APPLICATION NO.	FILING DATE	FIRST NAMED INVENTOR	ATTORNEY DOCKET NO.	CONFIRMATION NO.
10/760,242	01/21/2004	Kia Silverbrook	WAL04US	1572

Office Action Summary

DETAILED ACTION

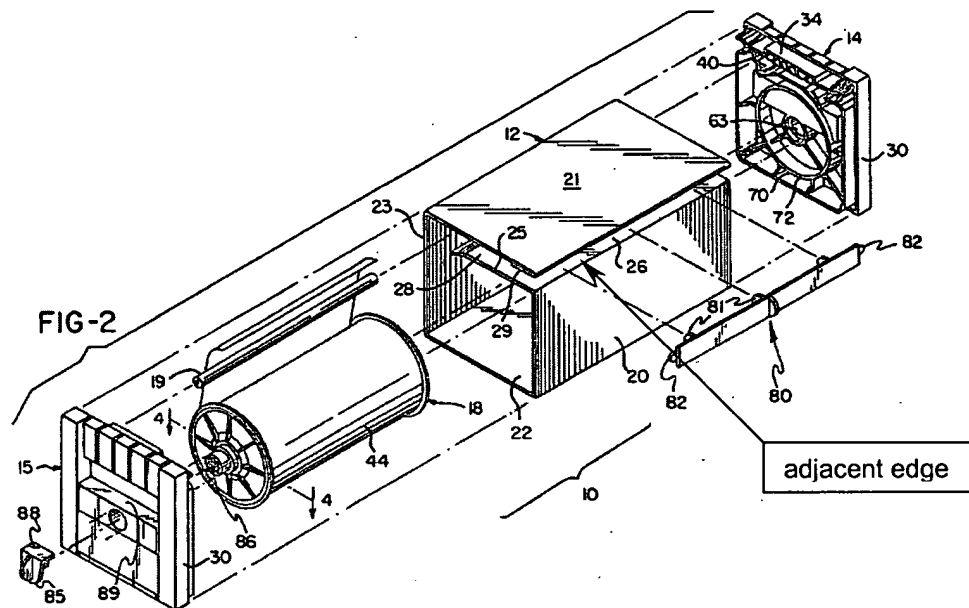
With respect to claim 2, Beery discloses a gap 26 between the access flap 21 and an adjacent edge as shown below from the Figure taken from Figure 2 of Beery:
